AMENDMENT TO APPROVED MASTER PLAN APPLICATION

**Re: *Transportation Master Plan Amendment Summary Letter
McCoy Retreat Center
San Marcos, Texas***

McCoy's Retreat Center
TMP Amendment

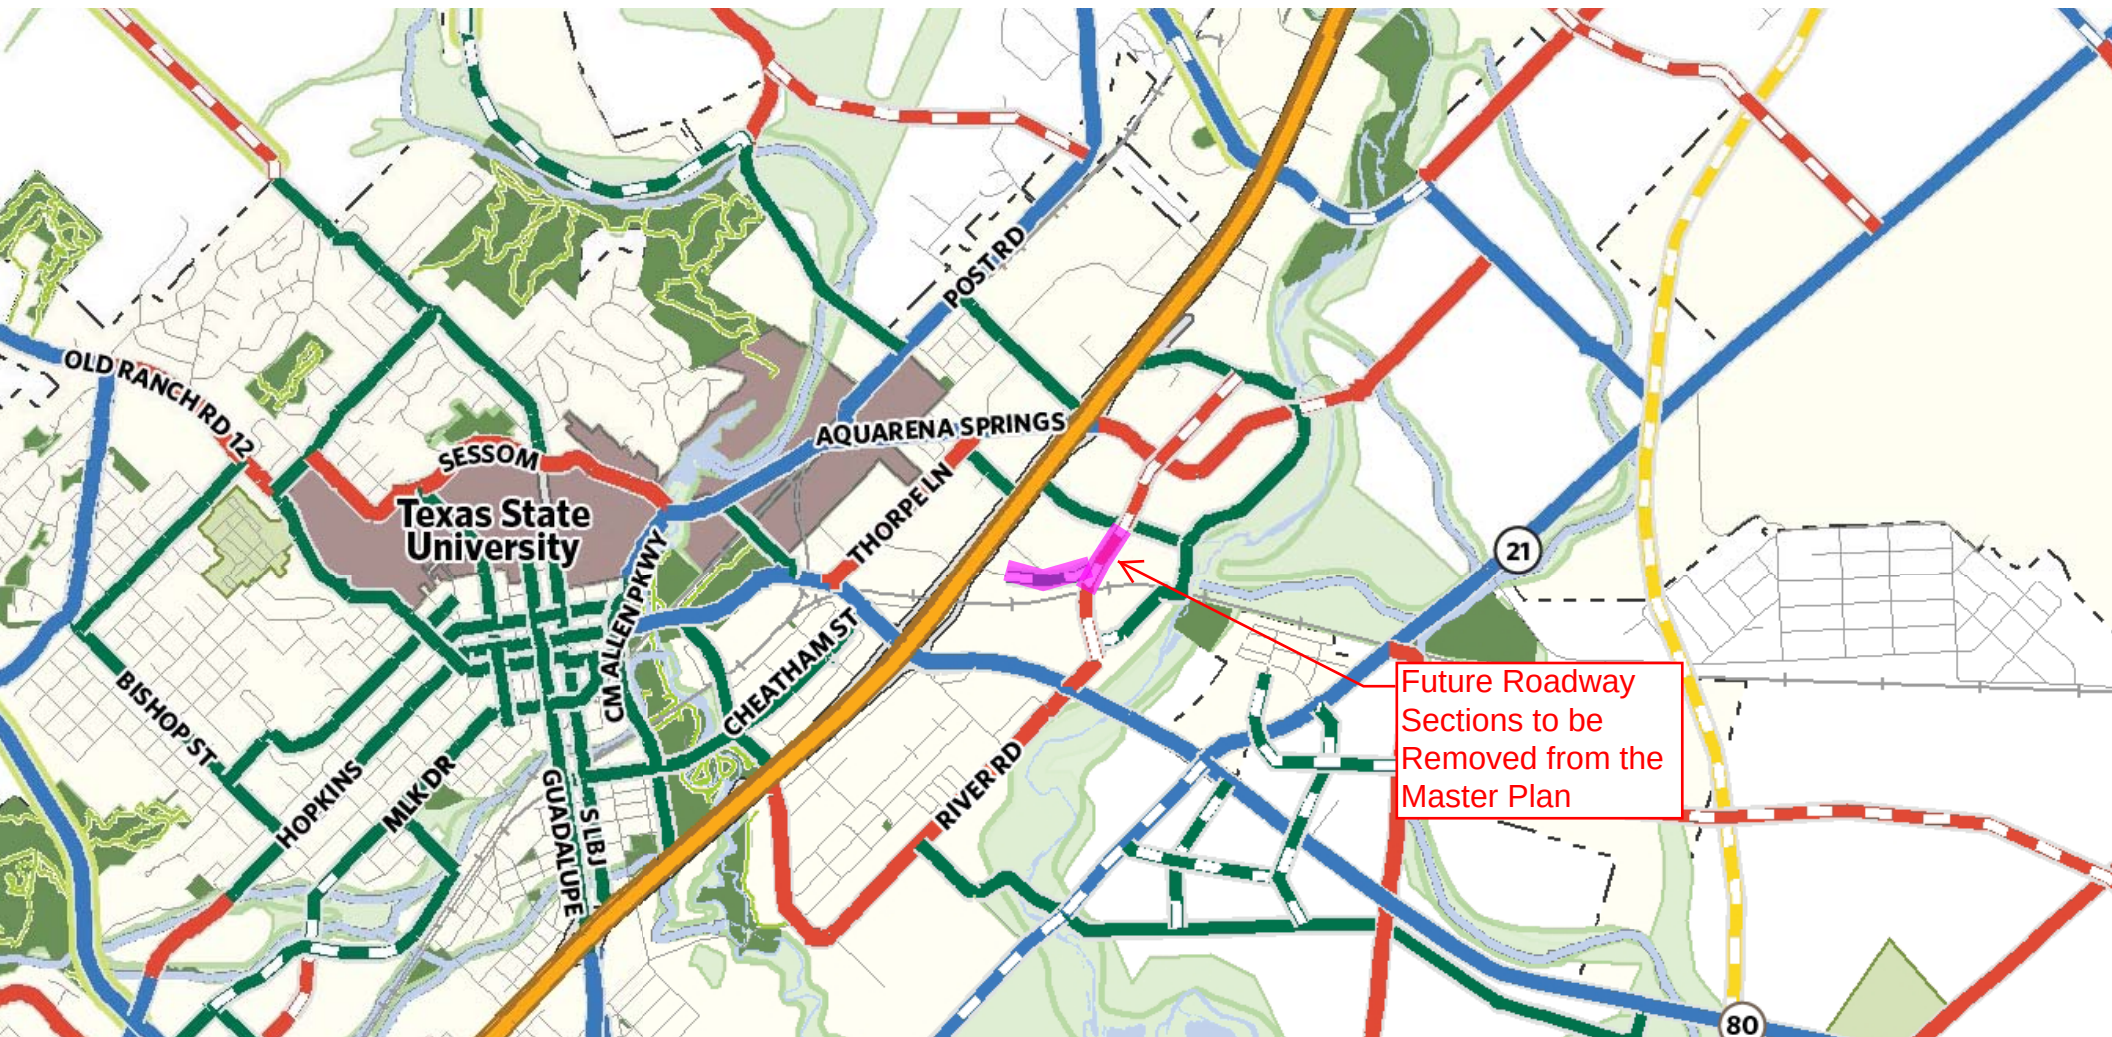
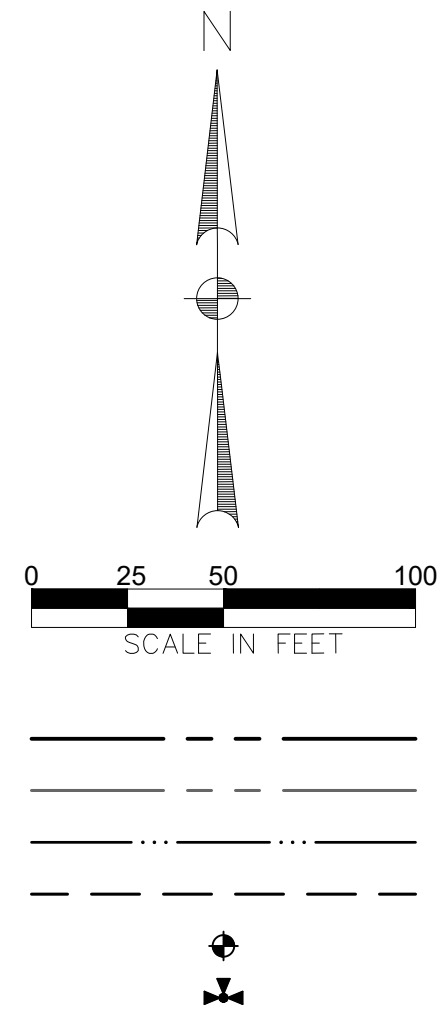
The TMP currently shows a Street extension through the heart of the site's oak groves that would connect McCoy Circle and the adjacent hotel development to Davis Lane. Additionally, the plan proposes a new Avenue that would run along the south side of the McCoy Office Subdivision Lot 2 connecting River Road to the south of the railroad to Davis Lane. The extension and locations of these proposed roadways would be in conflict with the intent of the proposed Retreat development. The new roads would further develop and pave over the natural landscape eliminating the private rural atmosphere of the subject

In summary, we respectfully request that the City amend the Transportation Master Plan to eliminate the proposed Street and Avenue extensions. Upon approval, our team will work closely with City Staff to comply with applicable codes and regulations for the subdivision and design of the project. If you should have any questions regarding this application or need additional information regarding the McCoy Retreat Center development, please feel free to contact us at 512-556-8160.

Future Roadway
Sections to be
Removed from the
Master Plan

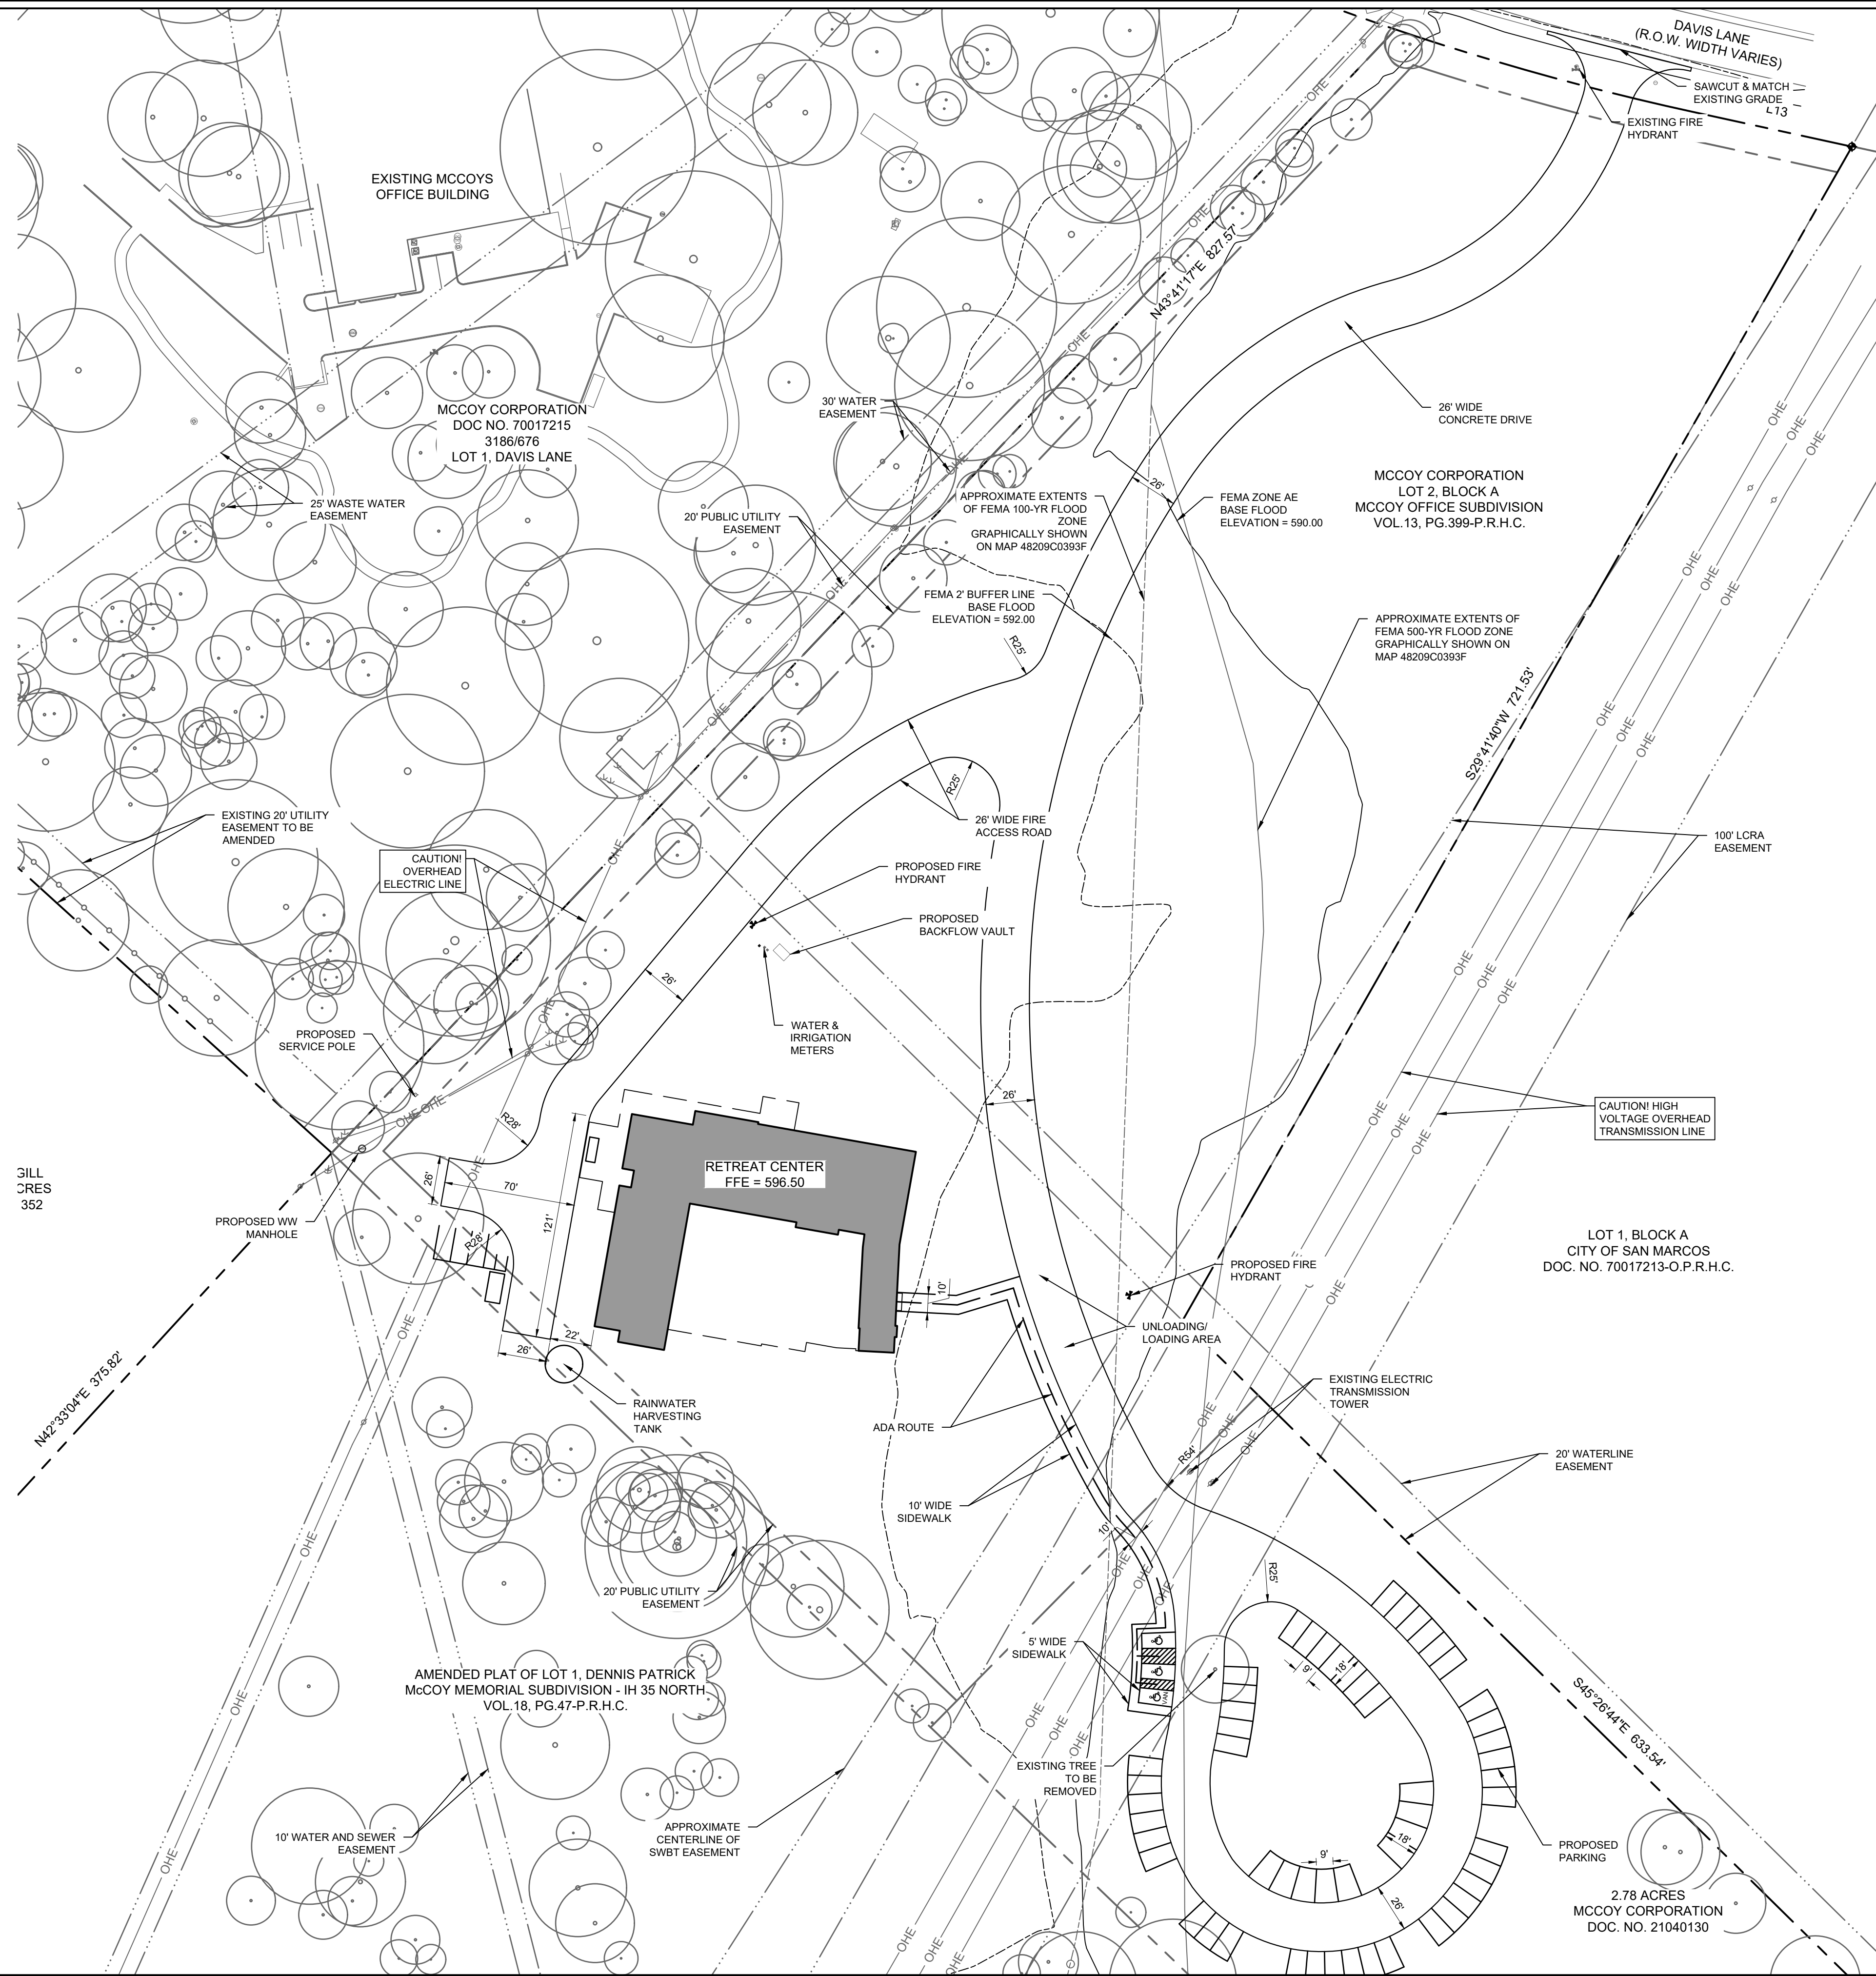
Highlighted Section
to be Removed
from Plan
